RE: Adequacy Review Response TR-08; M-1992-009

On behalf of Mr. Chris Pyles, owner and operator of Gillette Sand and Gravel, Inc., RealTime Aquifer Services (RAS) has prepared this document in response to your May 8, 2020, Adequacy Review for Technical Revision #8 (TR-08), dated April 10, 2020, and received by your office on April 14, 2020.

PROJECT: GILLETTE PONDS

Exhibit D Showing Sediment Pond Area

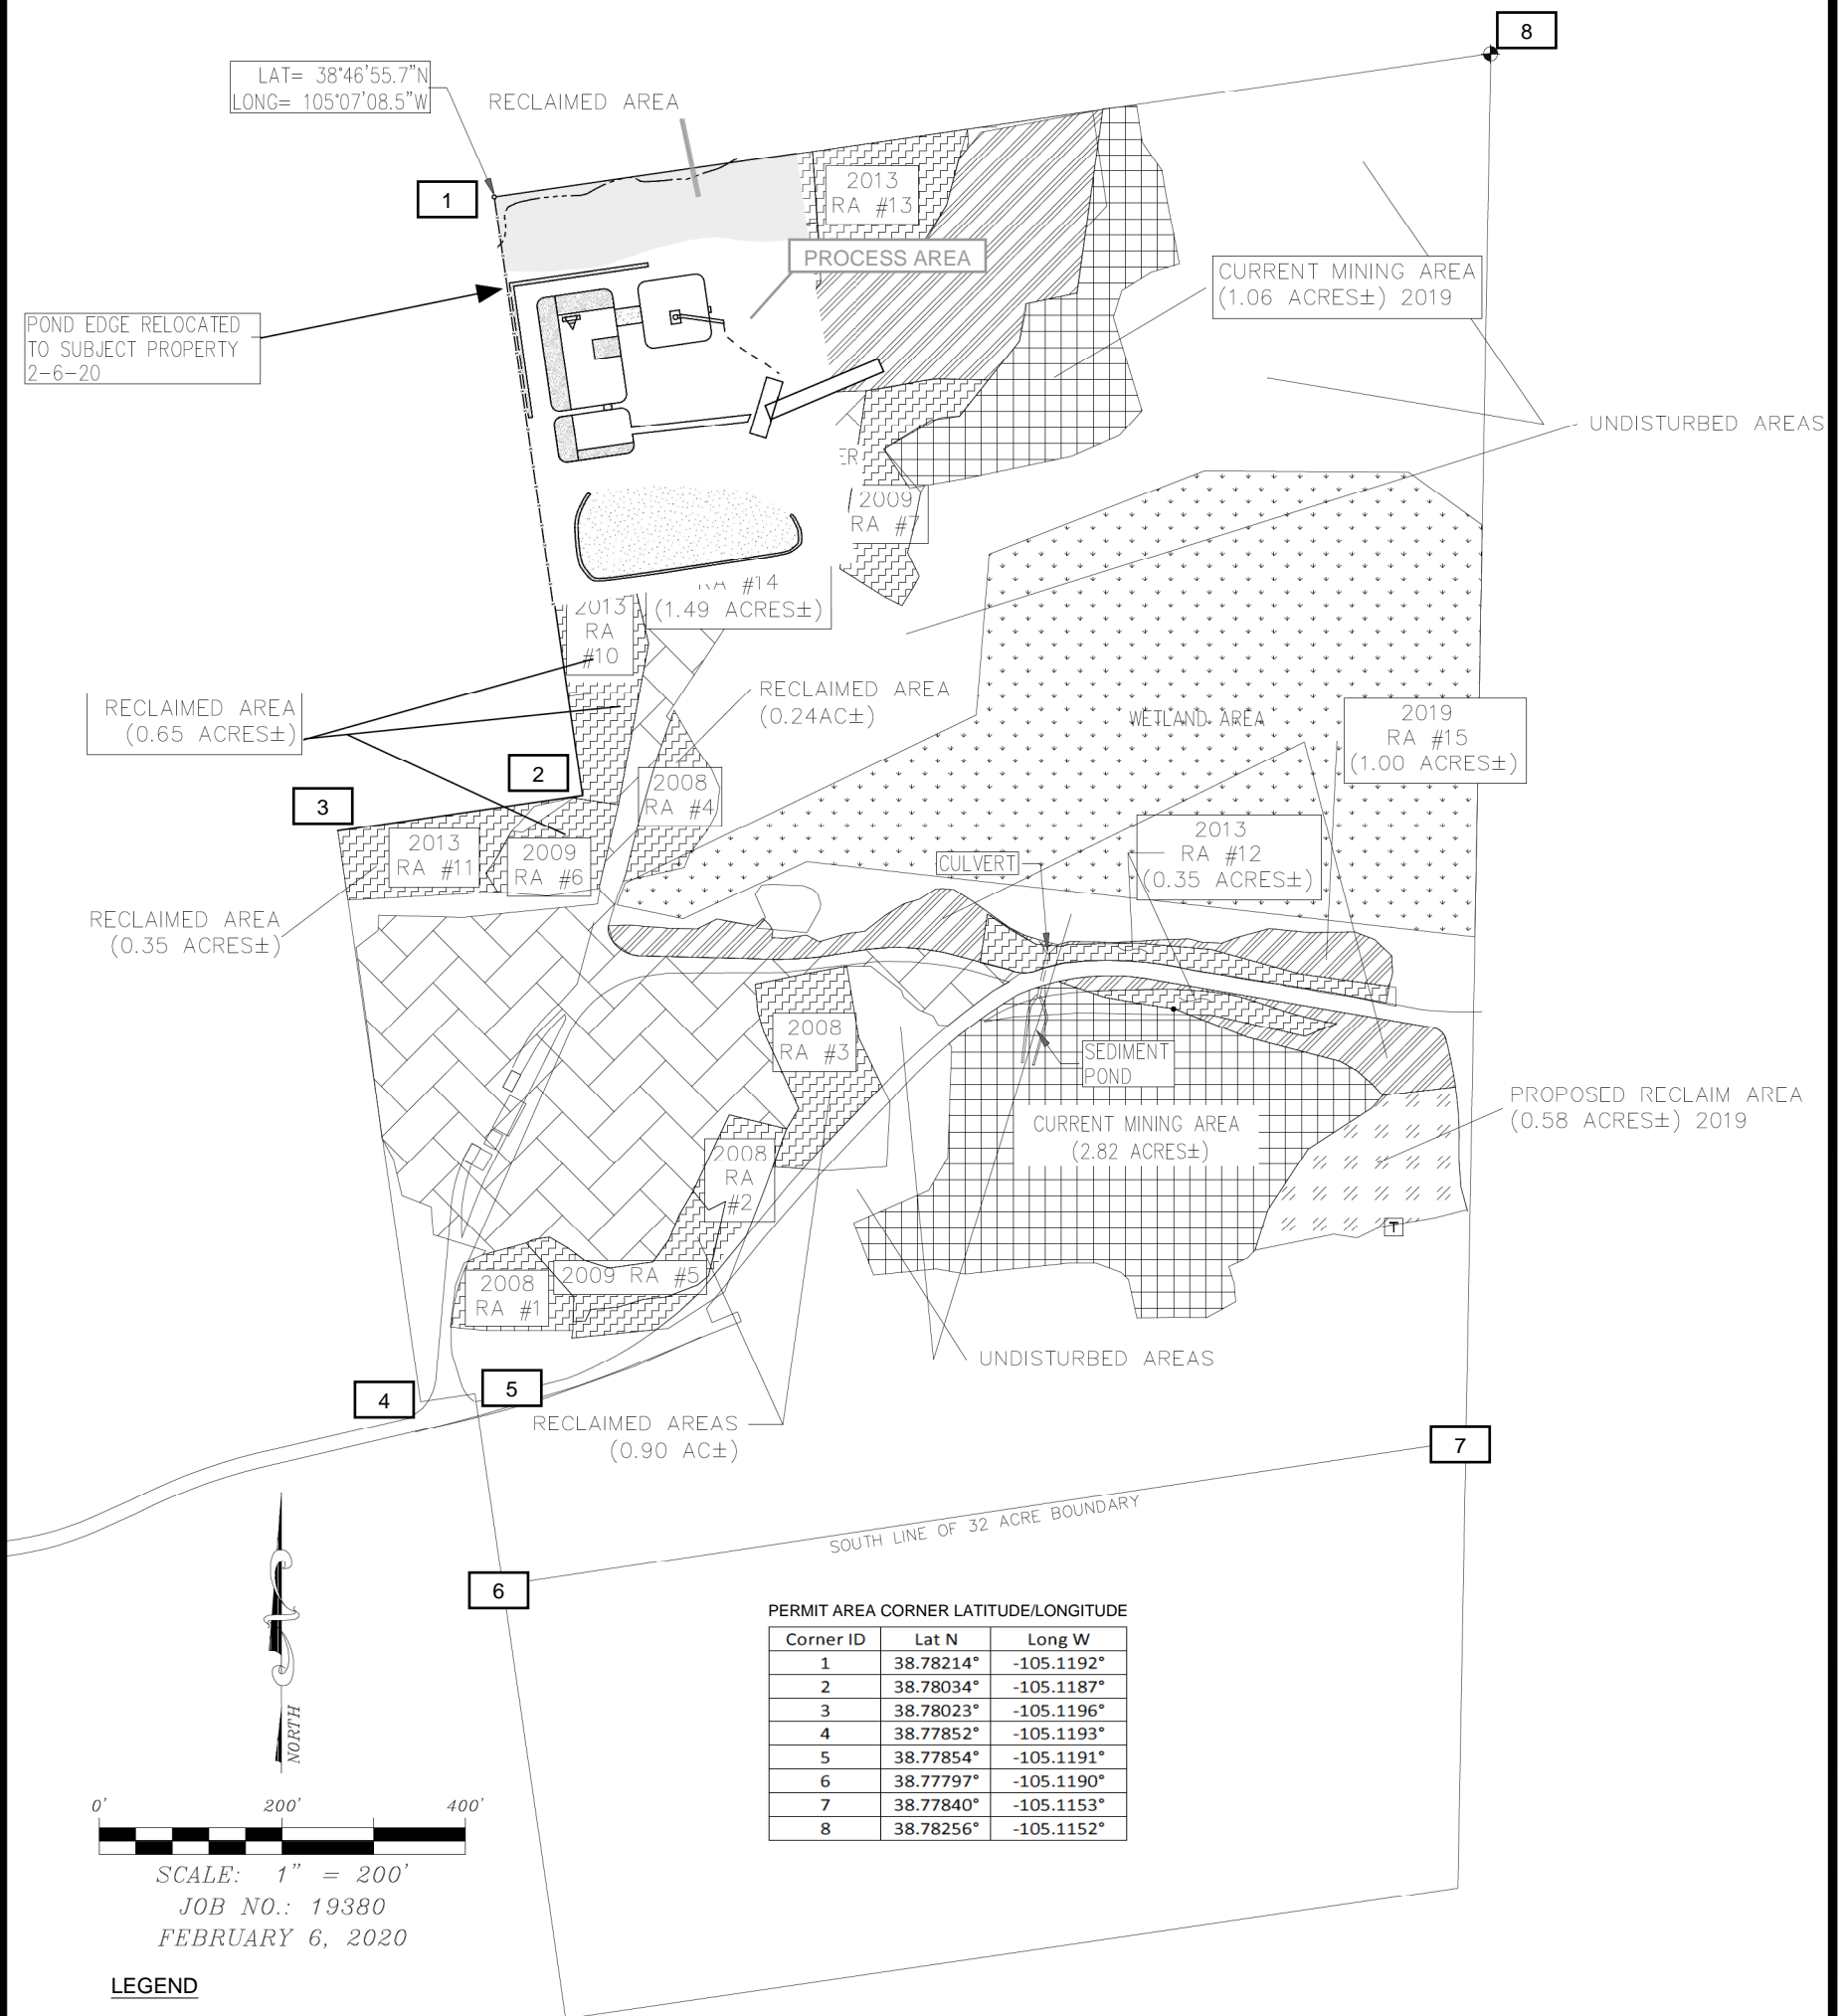
6. *Comment:* In accordance with Rule 6.2.1(2)(a), please revise the maps submitted to show the name of the Applicant (Gillette Sand and Gravel, Inc.). Additionally, in accordance with Rule 6.2.1(2)(b), maps must be signed.

7. *Comment:* The Exhibit D Map contains a label near the southern permit boundary which states 38.51 Acre Boundary. Please revise this to reflect the approved permit acreage of 32 acres.

8. *Comment:* The Exhibit D Map identifies the latitude/longitude coordinate for the northwest boundary corner. Please revise this map or provide a separate table, identifying the remaining seven permit boundary corners coordinates.

Response: Noted and agreed; the requested changes have been incorporated into the TR-08 maps.

Response: Noted; the acreage has been relabeled as requested on the Exhibit D Map.

Response: The decimal latitude and longitude for all eight corners of the permit area are posted on the following table. Corners are numbered on the Exhibit D Map.

This table has been posted onto the Exhibit D Map of the TR-08 document and the map has been annotated to show the corner locations.
